MONTGOMERY COUNTY HISTORIC PRESERVATION COMMISSION
STAFF REPORT

Address:	4 E. Kirke Street, Chevy Chase	Meeting Date:	9/17/2025
Resource:	Non-Contributing Resource Chevy Chase Village Historic District	Report Date:	9/10/2024
Applicant:	Cameron Ruppert Alexander Smith, Architect	Public Notice:	9/3/2024
Review:	Historic Area Work Permit	Tax Credit:	n/a
Case Number:	1106063 REVISION	Staff:	Dan Bruechert
Proposal:	Hardscape Alteration, Garage Demolition, and Accessory Structure Construction

The applicant proposes to add several retaining walls, a terrace, new steppingstone paths, and construct a wood pergola. The applicant also proposes to demolish the existing garage and construct a new accessory building.

Figure 2: Manufacturer's image of the proposed garden shed.

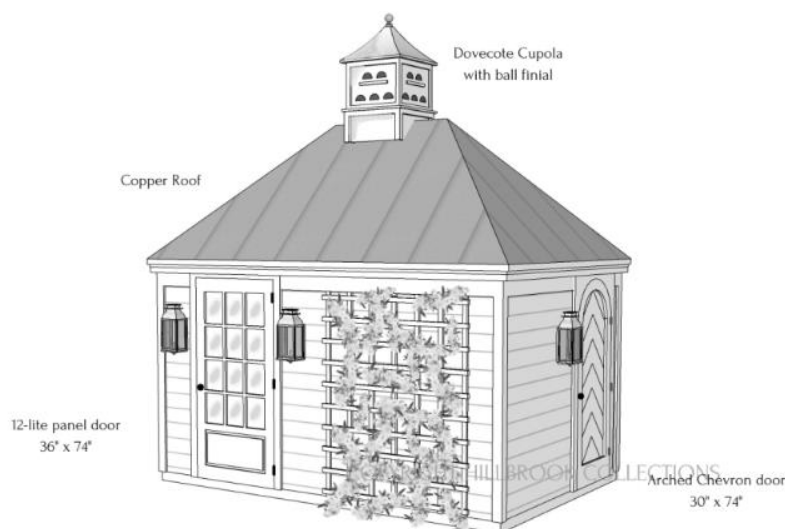
The proposed retaining wall will match the materials proposed for the wall along the left of the house, discussed above. To the south of the retaining wall, the applicant proposes to construct a garden shed, measuring approximately 7' × 10' (seven feet wide by ten feet deep), clad in wood siding, with a copper roof with a cupola. The shed includes a 12-lite panel door and a solid wood door. The placement of the shed, partially behind the house, coupled with the drop in grade at the rear of the property will leave the shed only minimally visible from the public right-of-way. Staff finds the proposed shed is compatible with the character of the site and surrounding district and will have less of an impact on the character of the site than the existing garage. Under a lenient scrutiny review, Staff finds the proposed shed is appropriate under 24A-8(b)(2) and (d), the *Design Guidelines*, and *Standards #2*, *9*, and *10*.
